Staff Report

Re: PLNPCM2021-00199 Brix Design Review

Design Review

SITE UTILITY PLAN

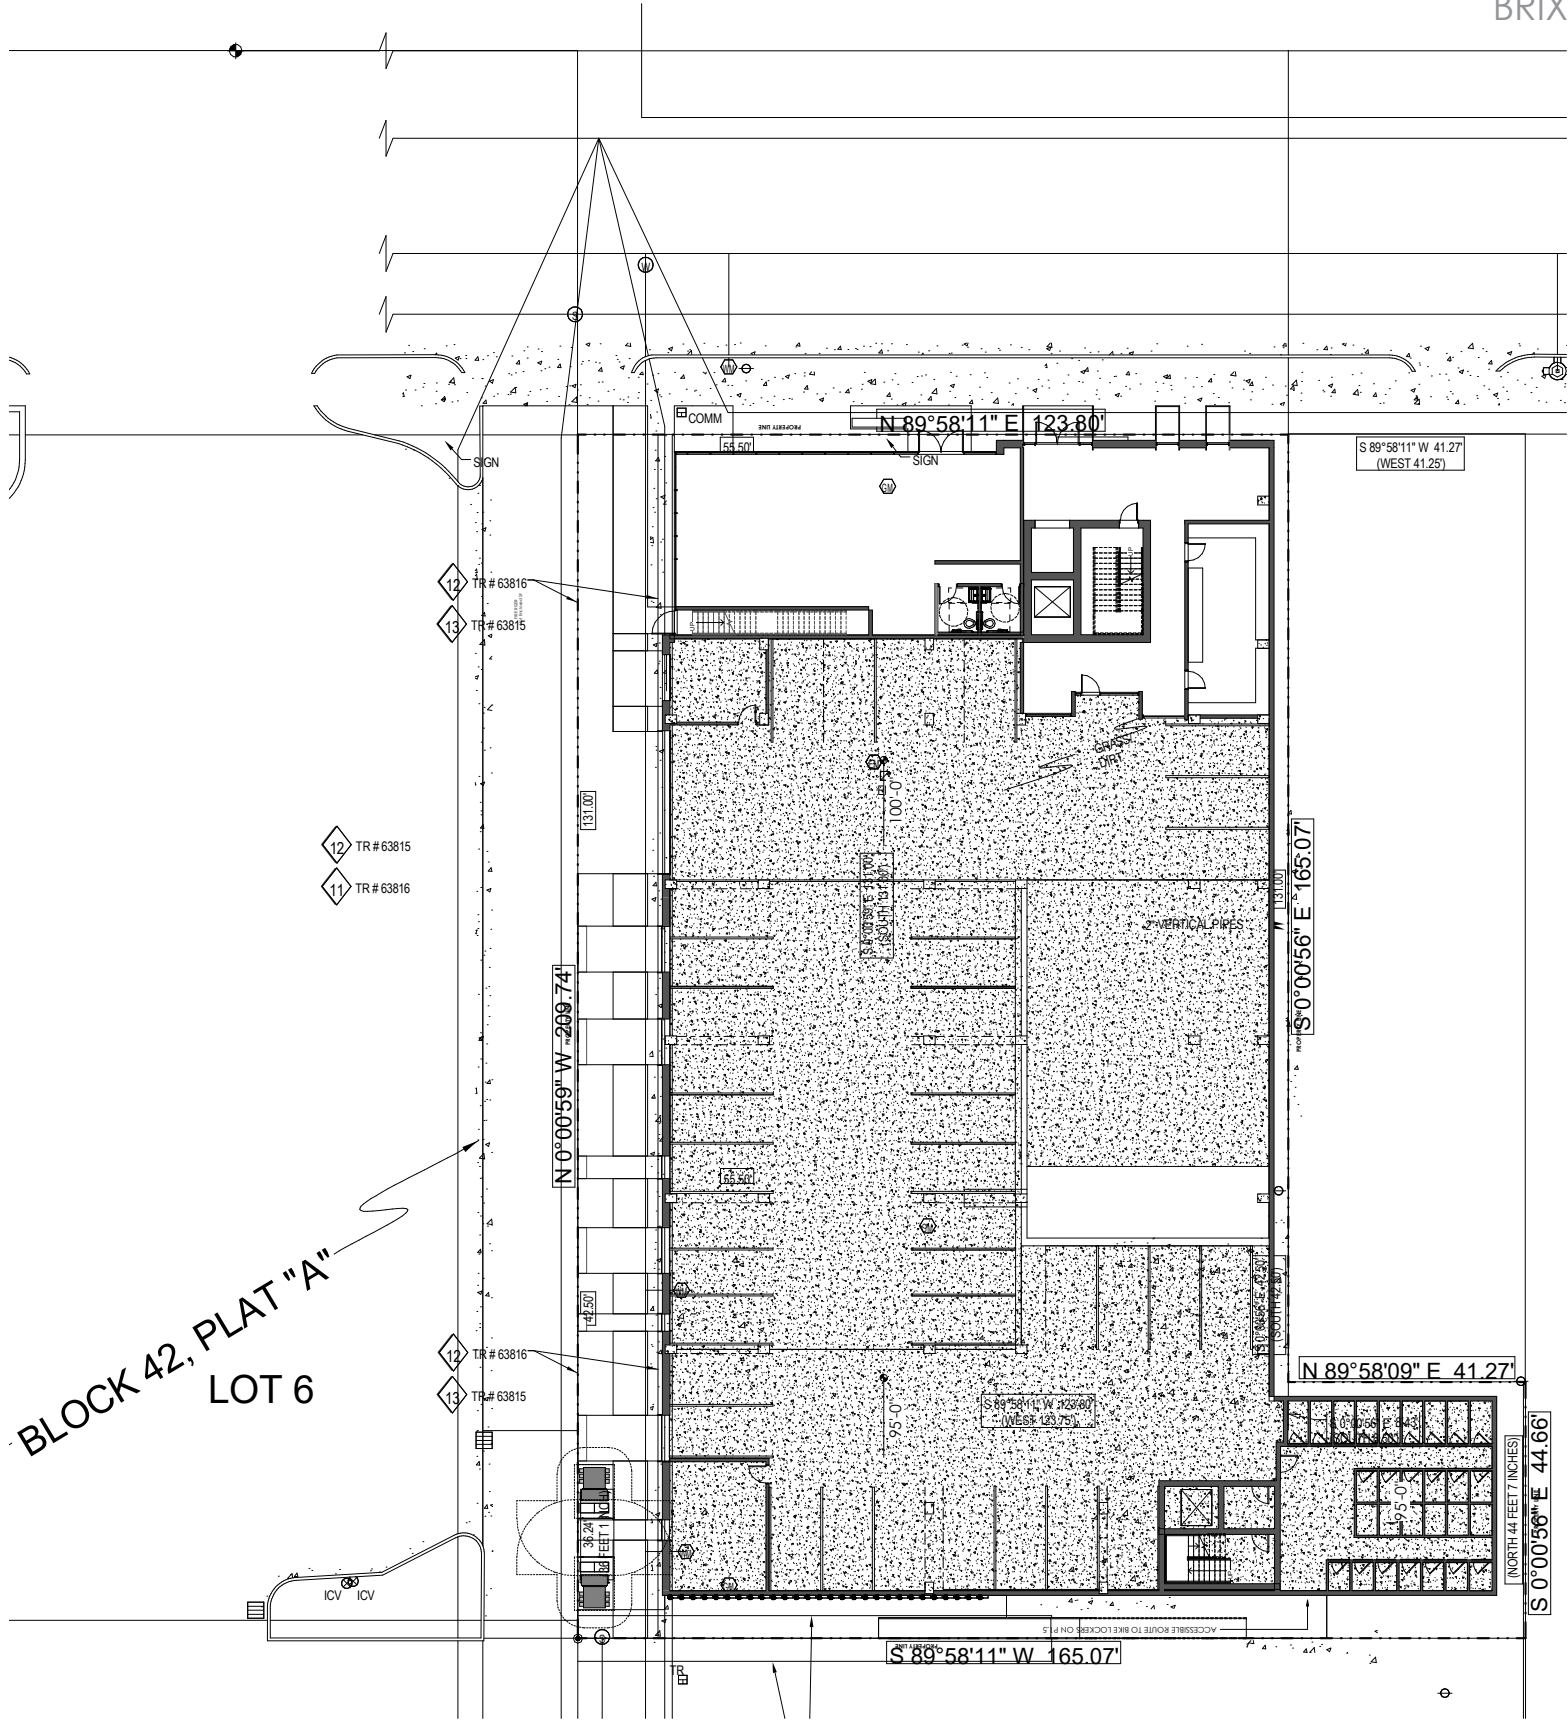
- L
- A minimum of one sewer lateral is required per building. Multiple may be permitted.
- M
- The 6" sewer lateral shown on the utility plan included with the Design Review submission shows connection to a public sewer manhole. This is not allowed – 6" laterals must connect via wye connection to the sewer main.
